STATE OF WASHINGTON
DEPARTMENT OF ECOLOGY

Periodic Review

**General Electric/Spokane Site
1997-2002**

**Prepared by:
Guy J. Gregory
Washington State Department of Ecology
Eastern Regional Office**

Figure 5b
MW-11
Aroclor Concentration and Water Table Elevation
GE/Spokane Site

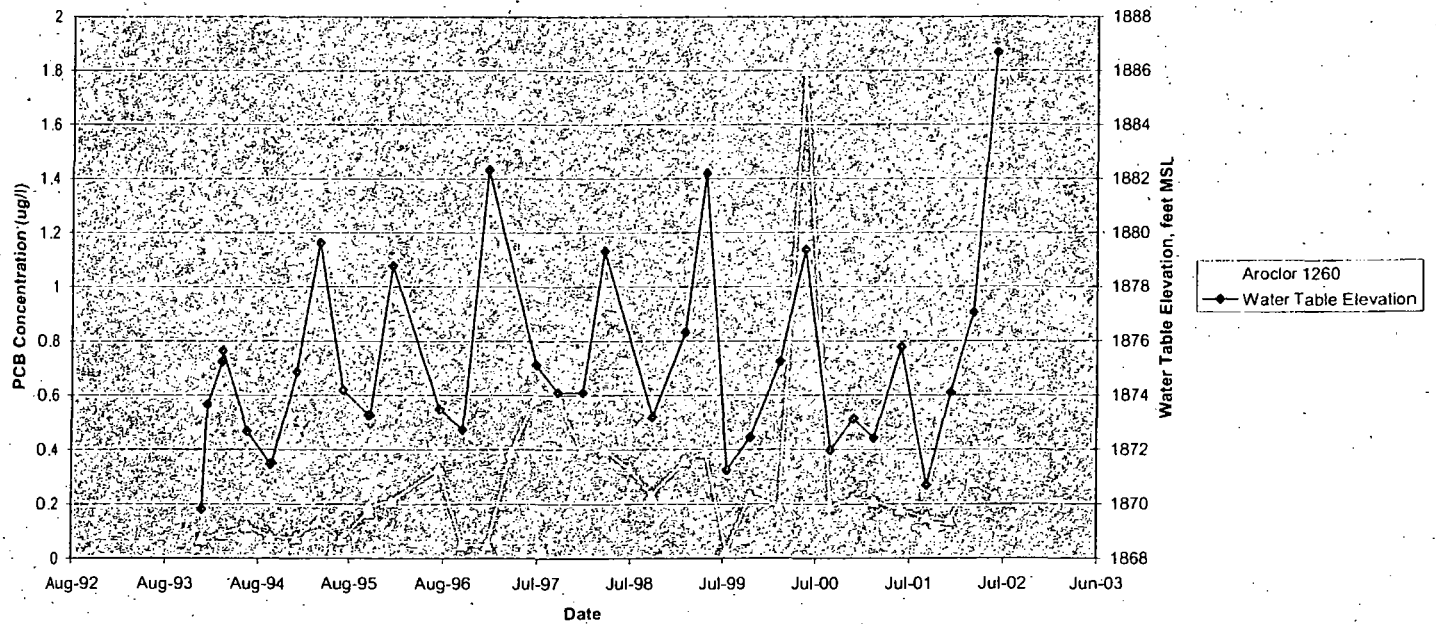
Data from MW-11 (Figure 5b) indicates a peak in Aroclor concentrations at the beginning of the review period. This is probably due to site disturbance activities. Data suggest a decreasing trend since 2nd Quarter, 1997, with the exception of an anomalous peak in the 2nd quarter of 2000.

Figure 5c
MW-18 PCB Concentration and Water Level
GE/Spokane Site

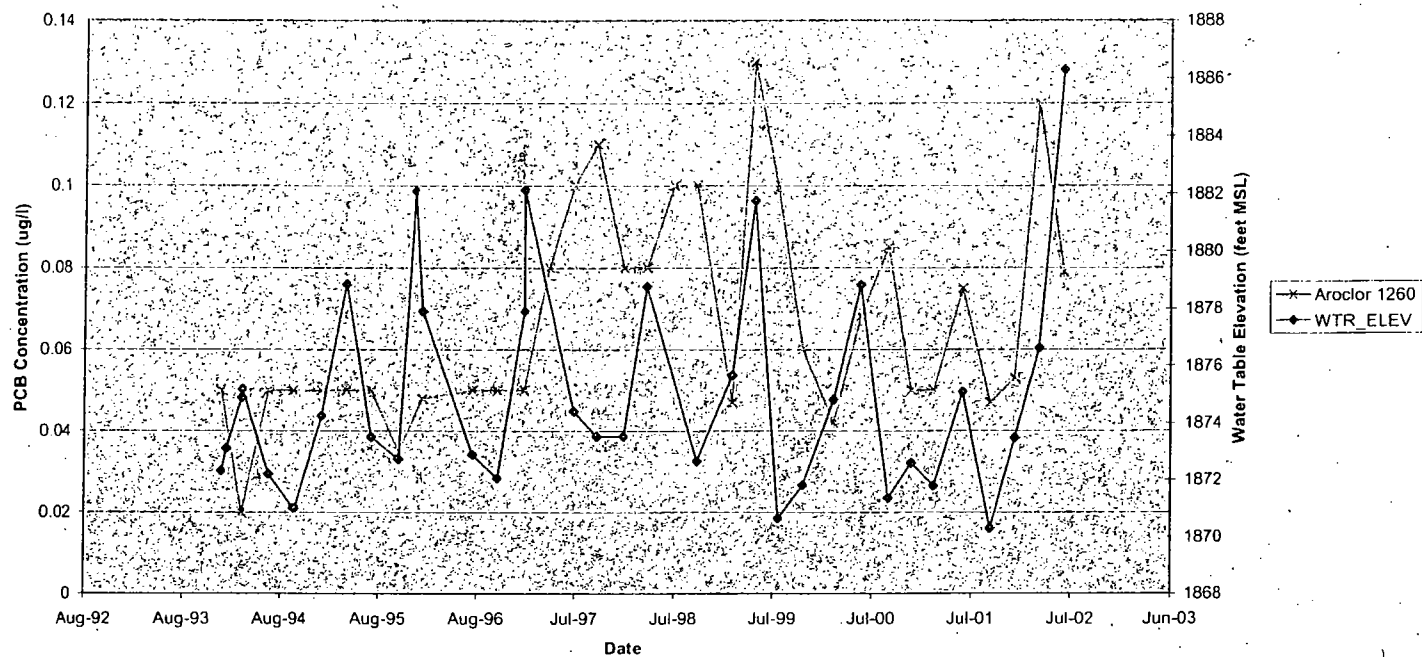
A similar pattern to MW-11, (Figure 5c) with a peak in concentration in 2nd Quarter 1997, followed by a generally subtle but present decrease in the observed maximum concentration. Anomalous peaks in 2nd quarter 1999 and 1st quarter 2002, as well as subordinate peaks in concentration in other years, seem related to the sharp spring rise in elevation common in the aquifer.

Figure 5d
MW-19 PCB Concentration and Water Levels
GE/Spokane Site

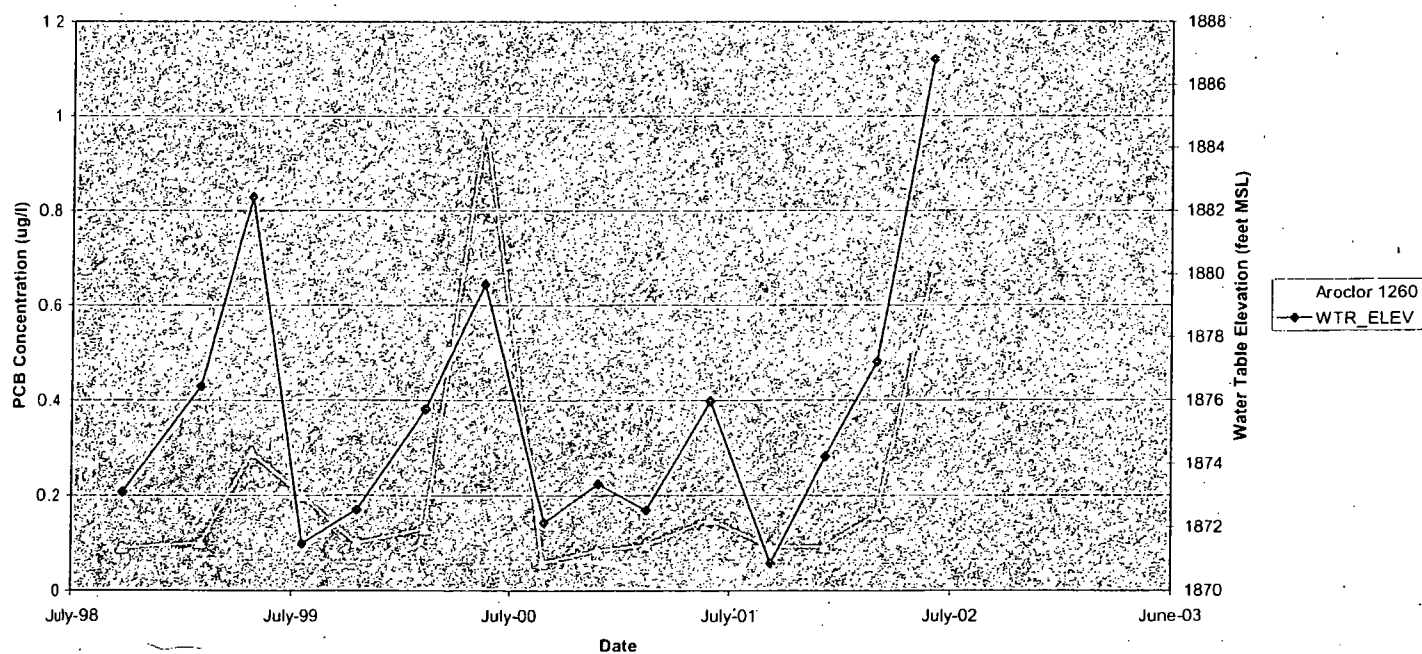
Monitoring in this well indicate values close to detection limits with the exception of detections of PCB in May or June (2nd quarter) sampling events. (Figure 5d)

Figure 5e
MW-20 PCB Concentration and Water Levels
GE/Spokane Site

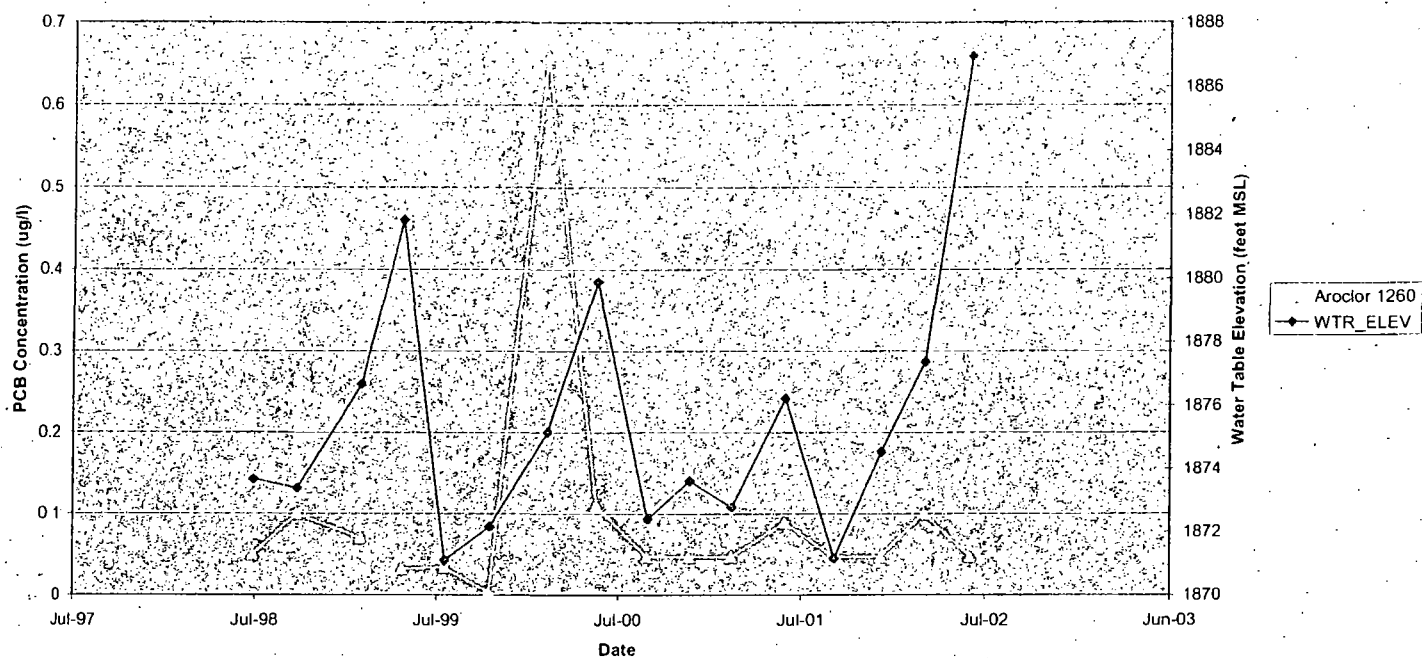
Contaminant trends in this well are generally flat, with the exception of the 1st Quarter (February) 2000 event, however highest concentrations again are generally associated with the sharp spring increase in water table elevation (Figure 5e).

Figure 5f
MW-21 PCB Concentration and Water Table Elevation
GE/Spokane Site

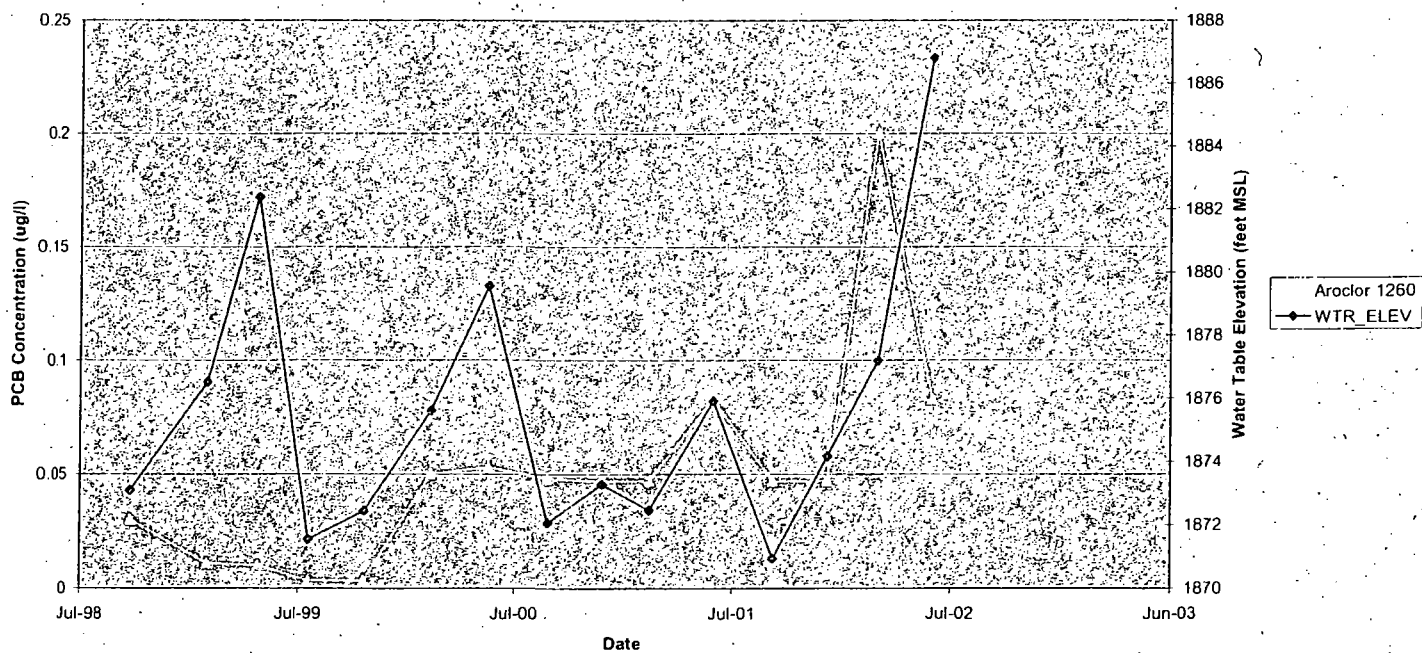
Slight detections occur in MW-21 associated with either the spring or summer ground water quality measurement. The concentration of those detections has increased from 0.053 ug/l to 0.2 ug/l (Figure 5f).

Figure 7
PCB Congener Concentrations-Detected Congeners only
GE/Spokane

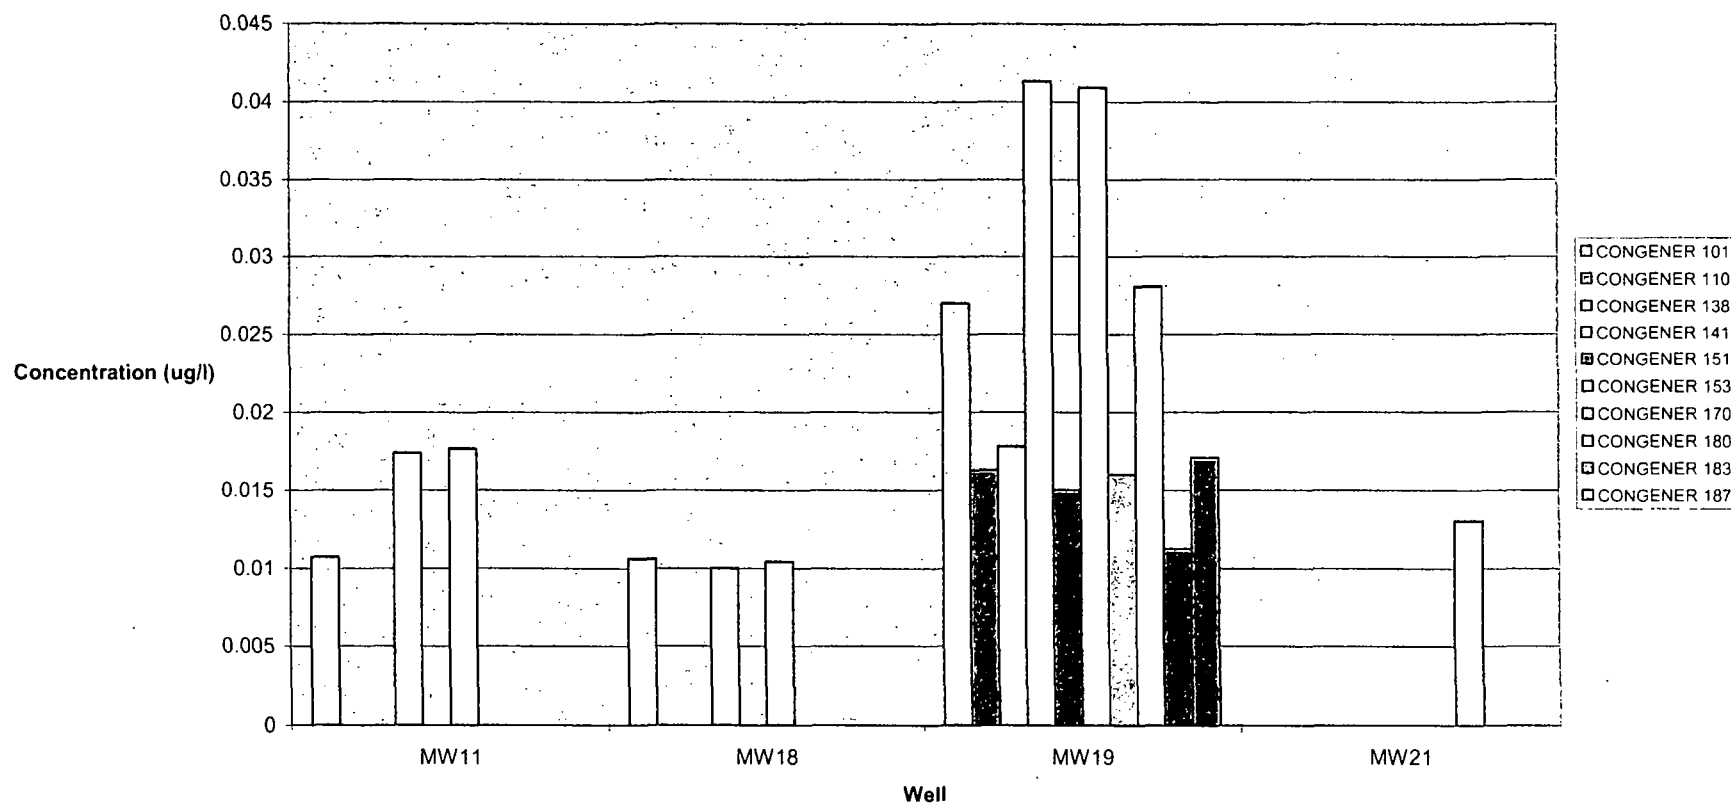
In addition to reporting Aroclors, Ecology required congener analysis be performed by the laboratory on the SAIC samples. Those data are indicated on figure 7, which shows detected congeners only. Congeners were detected in wells which detected Aroclors, and wells which had no Aroclors contained no PCB congeners. Higher concentration wells contained higher levels of congeners, but no correlation is apparent between the total detection of quantified congeners and the reported Aroclor concentration. Detection limits for the congeners are significantly lower than for Aroclor mixtures.
